U.S. Nuclear Regulatory Commission  
Attn: Document Control Desk  
Washington, DC 20555Limerick Generating Station, Units 1 and 2  
Facility Operating License Nos. NPF-39 and NPF-85  
NRC Docket Nos. 50-352 and 50-353

Subject: Second Ten-Year Interval Inservice Inspection (ISI) Program

**RESPONSE TO JUNE 21, 2001 QUESTIONS**

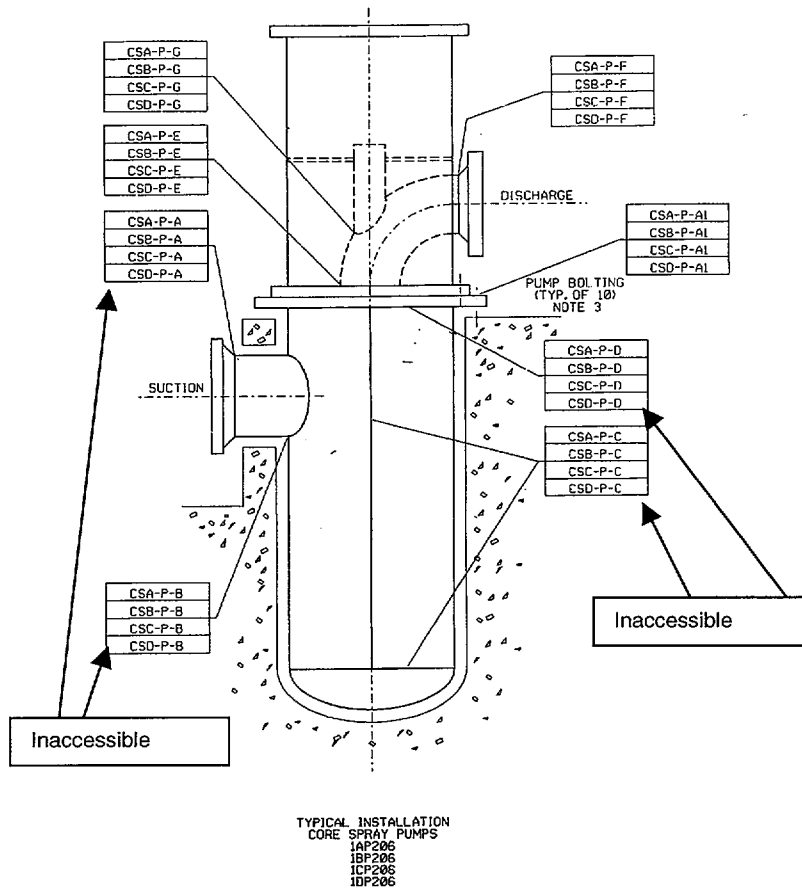
"2.1 Request for Relief No. RR-06, Revision 1 – Pursuant to 10 CFR 50.55a(g)(6)(i), the licensee requested relief from complete examination of the shell to flange weld on all heat exchangers in both Units due to limited access resulting from component design. The licensee proposed to perform the ultrasonic examination to the maximum extent practical (i.e., approximately 87.5%).

The licensee did not provide documentation, including photos, sketches, or calculations, to justify why the Code requirements are impractical. In addition, the licensee indicated that the limitations to complete volumetric examinations are also applicable to surface examination techniques. In order for the proposed relief to be acceptable, please provide the following:

- (1) For each of the four RHR heat exchangers (i.e., two in each Unit), demonstrate how the transverse scans using ultrasonic examination will achieve the maximum extent possible of 87.5% of the Code volume requirement. Include photos, sketches, drawings, or calculations as appropriate.
- (2) Justify why the access restrictions from the flange bolting are applicable to surface examinations for each of the four RHR heat exchangers."

- (1) A sketch showing the physical limitation to the RHR heat exchanger shell to flange welds is provided in Attachment 1. The 87.5% coverage is an estimate based on the obstructions created by bolting, which prevents obtaining the required code coverage.
- (2) The RHR heat exchanger shell to channel connection is a mechanical joint comprised of 64 (1 1/8") studs each secured with 2 heavy hex nuts. The diameter of the bolt circle is 58 5/8" and the shell outside diameter in the area of the flange bolting is 55 5/8" for LGS Unit 1 and 55 1/8" for LGS Unit 2. This places the nut for the shell to channel connection in the base

metal portion of the weld and required volume (WRV) of the shell to flange weld with the height of the nut interfering with access to the weld portion of the WRV. These restrictions prevent surface examinations of the shell to flange welds.

Ultrasonic examinations for reflectors parallel to the weld seam (axial scans) are performed from the shell side of the weld and are essentially complete using a sufficiently long examination beam path to provide coverage of the WRV in two beam path directions. Ultrasonic examinations for reflectors transverse to the weld seam (parallel scans) are performed on the accessible portions of the weld crown between the heavy hex nuts using one-half V path techniques.

The WRV adjacent to the 64 heavy hex nuts is inaccessible to ultrasonic scans due to the heavy hex nuts covering portions of the base metal and the height of the nut blocking access to portions of the weld seam. Therefore, the 87.5% coverage is an estimate based on the obstructions created by bolting, which prevents obtaining the required code coverage. The use of magnetic particle and liquid penetrant examination methods does not result in an increase of Code coverage since these same limitations to ultrasonic parallel scans preclude access to the WRV for surface preparation.

**Attachment 2**  
**Core Spray Pump**  
(Typical of 4 for each Unit)  
(Refer to Question 2.2)

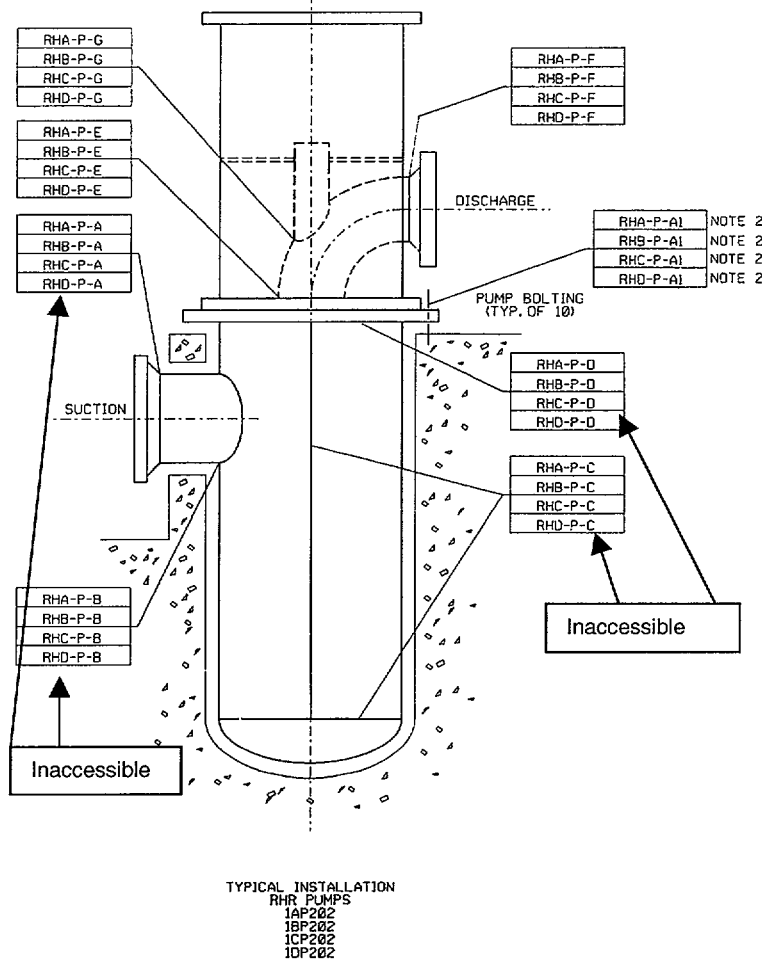
"2.2 Request for Relief No. RR-07, Revision 1 – Pursuant to 10 CFR 50.55a(g)(6)(i), the licensee requested relief from the examination of inaccessible pressure retaining pump casing welds on the RHR and Core Spray (CS) pumps due to plant/component design. The licensee's proposed alternative includes performing surface examination from inside of the pump casing when accessible, taking credit for visual examinations performed during system leakage and hydrostatic tests, and taking credit for functional tests.

The licensee proposed that in the event the subject welds become accessible upon disassembly of any one of the pumps, the welds will be surface examined from the inside surface or a VT-1 visual examination will be performed for that particular pump group to the maximum extent practicable. The examination method will be determined based on radiation environment data at the time access is enabled. In addition, all pumps are subject to the visual examination (VT-2) requirements during the system leakage test and the hydrostatic test of the Examination Category C-H, and the functional test of Section IWP, thereby providing assurance of pump structural integrity. In order for the proposed alternative to be acceptable, please provide the following:

- (1) For all 8 RHR and 8 CS pumps, demonstrate with photos, sketches, and/or drawings that none of the subject pump casing outside surfaces are accessible for surface examination.
- (2) Clarify the statement in the alternate provisions, "The examination method will be determined based on radiation environment data at the time access is enabled." Explain how the examination method to be chosen based on the radiation environment covers the Code required surface of the inside pump casing. Include the maximum and minimum Code-required surfaces that could be examined."

- (1) A sketch showing the physical limitation to the Core Spray (CS) pump and Residual Heat Removal (RHR) pump casing welds is provided in Attachments 2 and 3, respectively.
- (2) The RHR and CS pumps are deep well vertical shaft pumps. The RHR pumps are Ingersoll-Dresser model 34APKD four stage enclosed impeller pumps. The CS pumps are Ingersoll-Dresser model 25APKD six stage enclosed impeller pumps. The number in the model identifier corresponds to the pump diameter. The pumps are supported in the vertical position by a mounting flange that is welded to the shell. The shell, which is fabricated from welded plate, encloses the pumping element and provides for immediate containment of the liquid being pumped. The shell contains a suction nozzle that is flanged for connection to the piping system.

The deep well construction of the pumps has resulted in the outside surface of all shell fabrication welds being encased in concrete. Access to these welds is only enabled from inside the shell when the pump is disassembled and the pumping element is removed. Pump disassembly and removal of the pumping elements results in a significant breach in emergency core cooling system piping. However, when removal is required for pump maintenance or repair, radiological conditions may necessitate leaving the shell filled with water in order to provide a level of shielding to keep dose to personnel as low as reasonably achievable. The shell, filled with water, precludes access to the inside surface of the welds to surface examination techniques; however, remote visual examinations can be performed of the weld and adjacent base metal in accordance with IWA-2210.
